UNITED STATES PATENT AND TRADEMARK OFFICE

APPLICATION NO.	FILING DATE	FIRST NAMED INVENTOR	ATTORNEY DOCKET NO.	CONFIRMATION NO.
10/724,275	11/26/2003	Douglas Allard	11533.0028.NPUS00	8914

Office Action Summary

DETAILED ACTION

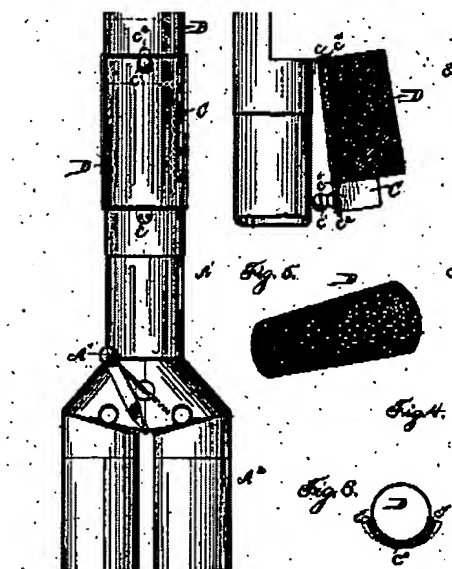
Buckley teaches a downspout filter apparatus that discloses all the limitations of claims 1-7, 10, 19-23 and 29-32 including a plurality of filters each having filter elements or screens. Filters Drawers C and D are considered by the examiner to be "cartridges". An outer housing A is provided about the cartridges. In operation, rainwater from a downspout is filtered while flowing through the plurality of filters and the filtered water returns to the

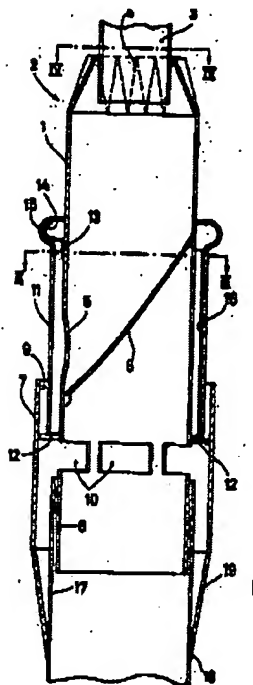
Minnemeyer teaches a filter in a downspout from an eave. A diverter A³ directs the filtered rainwater either to the outlet or to a second outlet leading to a cistern. As shown in the drawings the rest of the limitations of the aforementioned claims are met.

U.S.C. 102(b) as being anticipated by Huppert (U.S. 3,628,668).

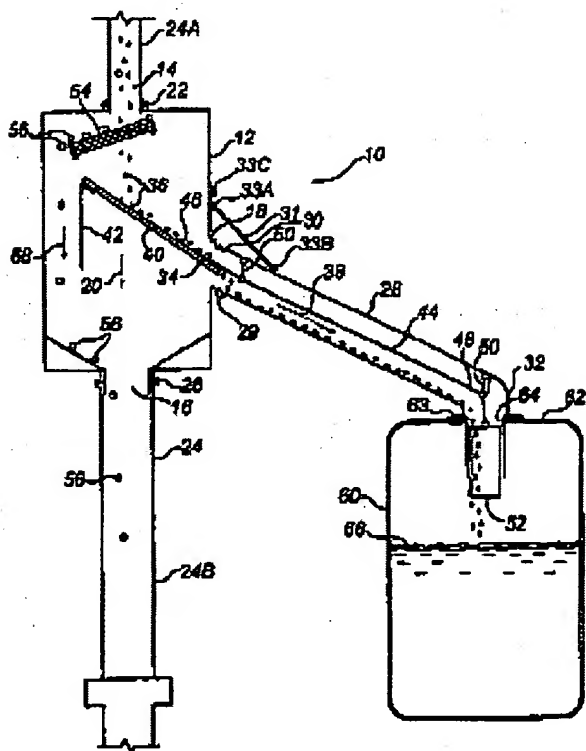
Huppert teaches a filter including a screen element 6 positioned between the inlet 3 and outlet 17 of a downspout. A primary bypass passageway is provided via aperture 5 and apertures 10, as in the aforementioned claims.

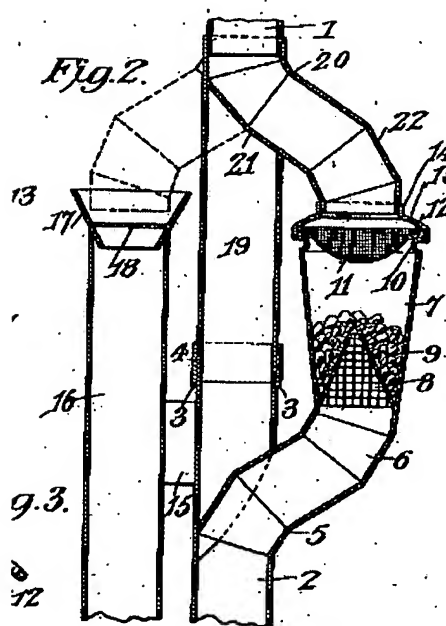
Doiron teaches an apparatus including a filter element 54 for filtering rainwater. Element 34 acts as a valve diverting water to or away from a second outlet leading to a barrel 60. Arrow 58 depicts an alternate flow path for the water when the filter is

clogged or capacity exceeded.
